CASE No. 2020-00272
FLAT RUN SOLAR, LLC
RESPONSES TO SITING BOARD'S FIRST REQUEST FOR INFORMATION
RESPONSES TO BBC RESEARCH AND CONSULTING'S FIRST REQUEST FOR INFORMATION

Response to Comments
Sound Evaluation-Supplemental Information
Flat Run Solar Project
Taylor County, Kentucky

Table 1
Source: Central Inverters

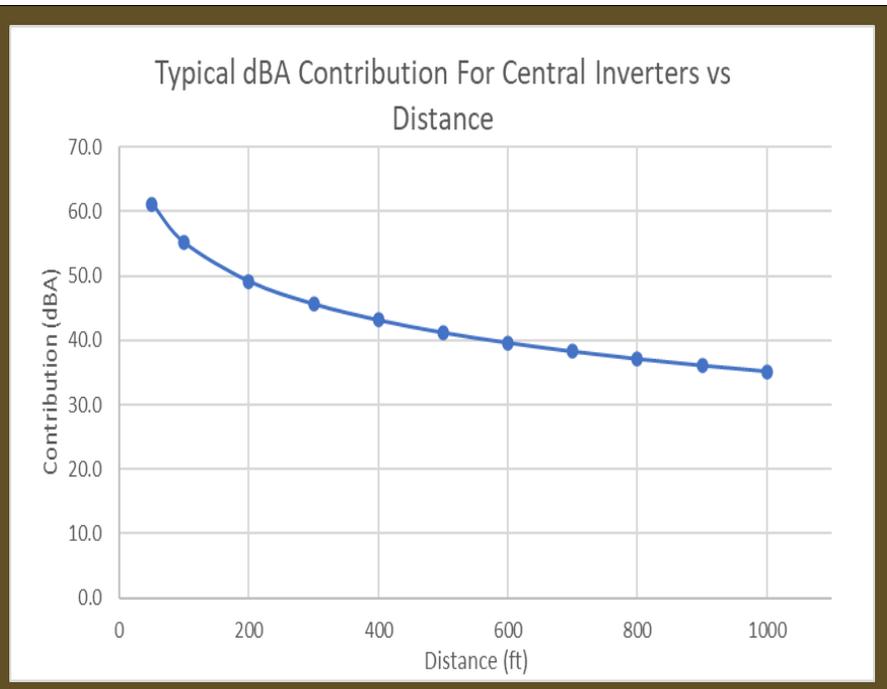
Comment: Provide the noise level generated at the source and at increments of 100 feet up to 1,000 feet for central inverters and string inverters.

Response: See Tables 1 and 2 below.
